Access Compliance Report

Public Rights-of-Way

Intersection ID: 14278	Main Street: ROMARE_BEARDEN_DR	Cross Street: FARMER_ST	Location:	E
ADA ID: 114DFF430824	Ramp Type: MedianPerp	Initial Pass/Fail: Fail	Overall Compliance: No	Severity Score: 22.5
Codes/Mitigation Info/Possible Solution		Field Measurements/Component Compliance

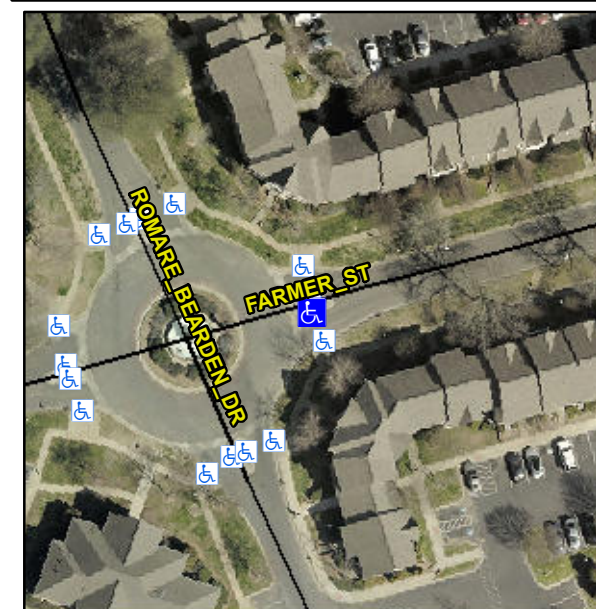
Not Found, R304.5.1, R304.2.2

Compliance	Description	Data	Compliance	Description	Data
N/A	Ramp Length (in)	40.0	No	Ramp Slope (%)	8.7
No	Ramp Width (in)	45.0	Yes	Ramp XSlope (%)	4.7
N/A	Flare Type LT	N/A	N/A	Flare Type RT	N/A
N/A	Flare Slope LT (%)	N/A	N/A	Flare Slope RT (%)	N/A
N/A	Flare Traversable LT?	N/A	N/A	Flare Traversable RT?	N/A
N/A	Landing Length (in)	N/A	N/A	DWS Provided?	N/A
N/A	Landing Width (in)	N/A	N/A	DWS Contrast?	N/A
N/A	Landing Slope (%)	N/A	N/A	DWS Length (in)	N/A
N/A	Landing X Slope (%)	N/A	N/A	DWS Full Width?	N/A
N/A	Landing Curb? (Y/N)	N/A	N/A	DWS Offset (in)	N/A
N/A	Shared Landing?	N/A			
N/A	Gutter Ponding?	N/A	N/A	Gutter Slope (%)	N/A
N/A	Gutter Lip Ht (in)	N/A	N/A	Gutter X Slope (%)	N/A
N/A	Painted X Walk1?	No	N/A	Painted X Walk2?	N/A
	X Walk 1 Direction	To S		X Walk 2 Direction	N/A
N/A	X Walk 1 Width (in)	N/A	N/A	X Walk 2 Width (in)	N/A
	X Walk 1 Slope (%)	0.7		X Walk 2 Slope (%)	N/A
	X Walk 1 X Slope (%)	4.7		X Walk 2 X Slope (%)	N/A

Remove & Replace Entire Ramp.
